**Economic Commission for Europe****Inland Transport Committee****World Forum for Harmonization of Vehicle Regulations****Working Party on Passive Safety****Seventy-fifth session**

Geneva, 27–31 May 2024

**UN Regulation No. 127 (Pedestrian safety)****Proposal for Supplement 3 to the 03 Series of Amendments  
and Supplement 2 to the 04 Series of Amendments to UN  
Regulation No. 127 (Pedestrian safety)****Submitted by the experts from Germany, France, the Netherlands, and  
the International Organization of Motor Vehicle Manufacturers<sup>\*,\*\*</sup>**

"Figure 13

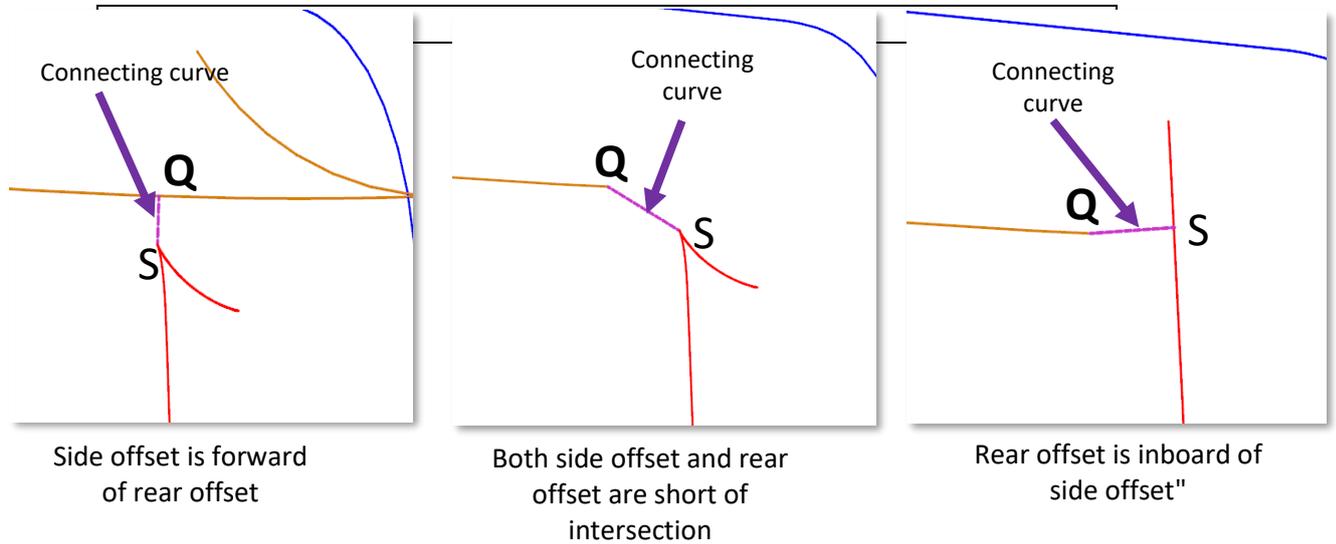
Paragraph 2.44., Figure 13, amend to read:

**Upper Corner Definition with "Shortest Distance"**

**If there is no intersection between (b) and (c) and the open test area is closed by a connecting line, as illustrated in Figure 13, then the „Q point" is defined by the centre of this connecting line."**
